June 10, 2015

**RE: Warehouse, 4455 Anaheim  
Grading and Drainage Plan  
Engineer's Stamp Date 5-13-2015 (File: C17-D123)**

Based upon the information provided in your submittal received 5-14-15, the above referenced plan cannot be approved for Building Permit until the following comments are addressed:

ENGINEER'S SEAL	4455 ANAHIM NE	DRAWN BY WCUJ
	<b>GRADING AND DRAINAGE PLAN</b>   <b>Rio Grande Engineering</b> 1606 CENTRAL AVENUE SE SUITE 201 ALBUQUERQUE, NM 87106 (505) 872-0999	DATE 5-13-15
		SHEET # —
5/13/15	DAVID SOULE P.E. #14522	JOB # 21515

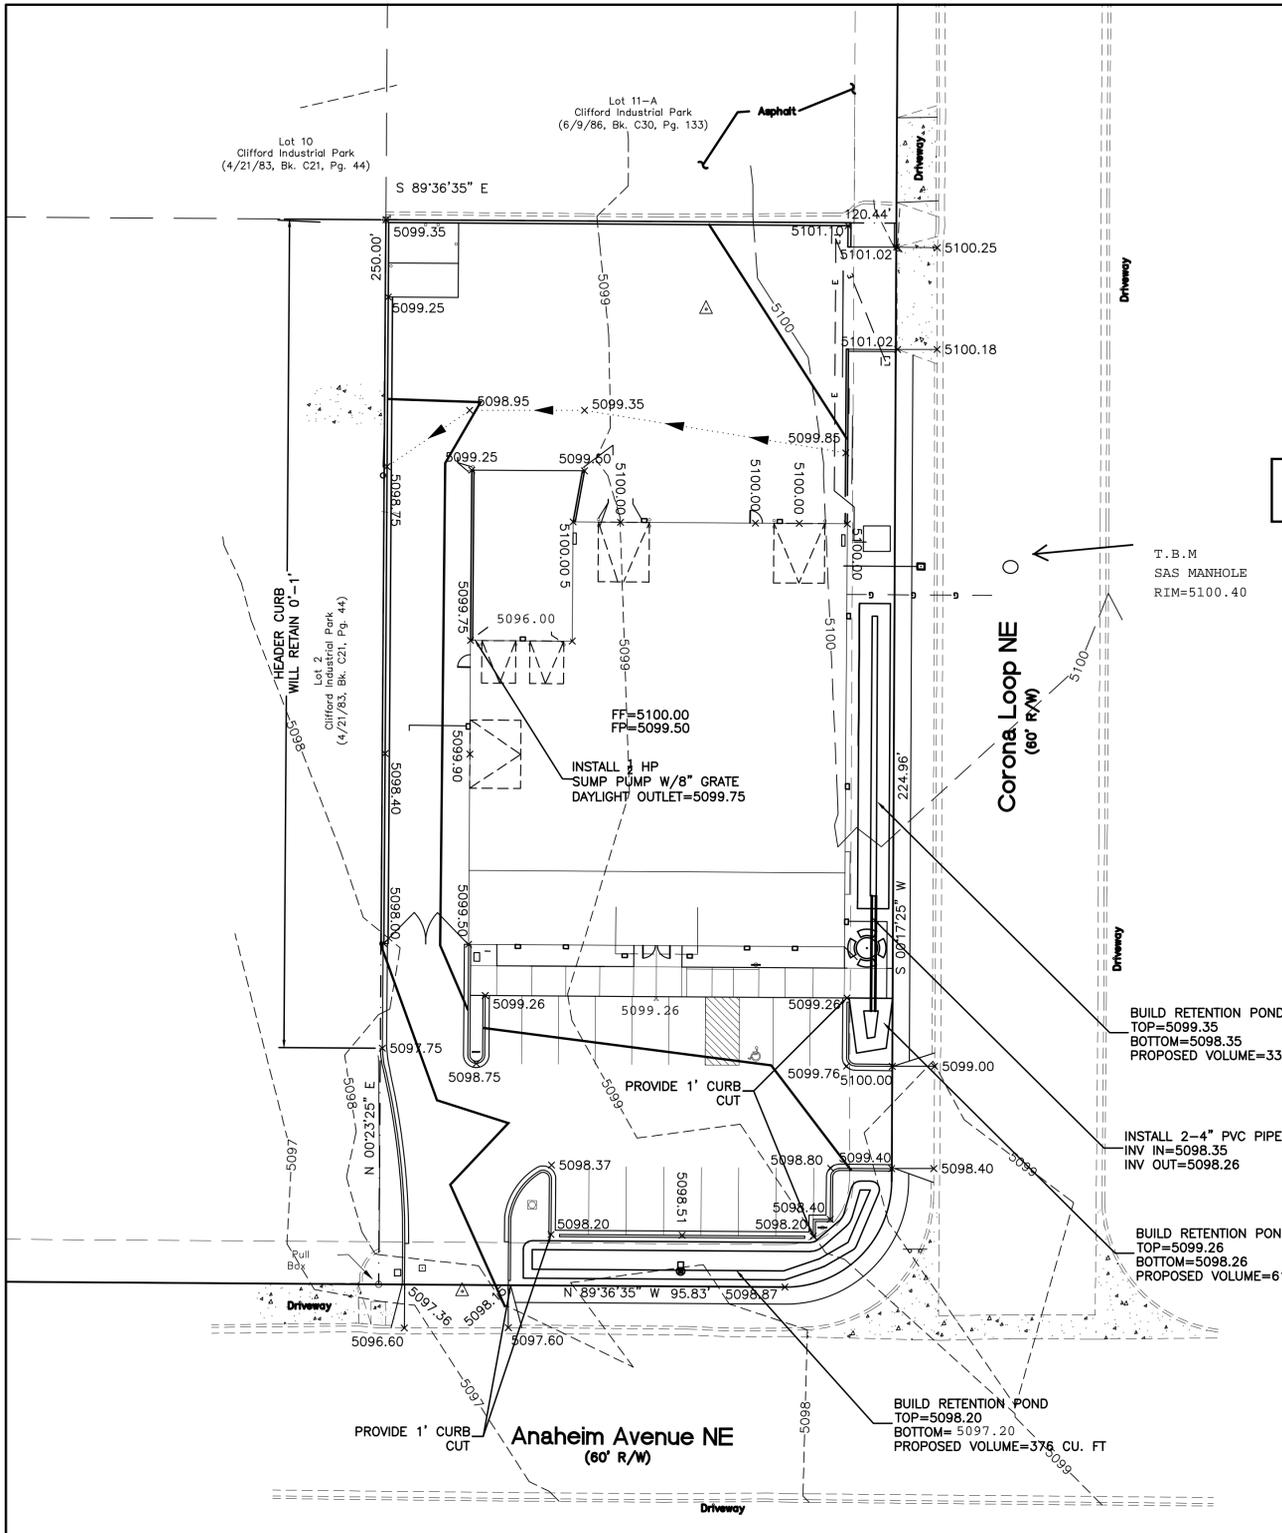
- 1) Provide new and existing curb linetypes and building boundary within legend. Label any gravel areas as "gravel" and paved areas as "paved", and count gravel lot areas as land treatment type "C". Label any new curb and curb height on the plan view as applicable.
- 2) Show roof drain locations.
- 3) Show existing spot elevations for curb on Corona Loop and on Anaheim Avenue. Label proposed contours, and additionally provide boundary lines around each of the pond areas that define the top and bottom elevations of the pond. For the three retention ponds, indicate that they are for the "first flush" if this is the case. If new spot elevations provided are at flowline of curb, provide general note stating this.
- 4) Correct minor discrepancy in the drainage report which shows a discharge of 2.93 cfs under "Proposed Conditions" discussion and 2.36 cfs under "Summary and Recommendations".

- 5) For existing conditions analysis, it is recommended to analyze the parking lot as "C" land treatment as a compacted lot. This results in less of a difference shown for proposed discharge of the site versus existing discharge.
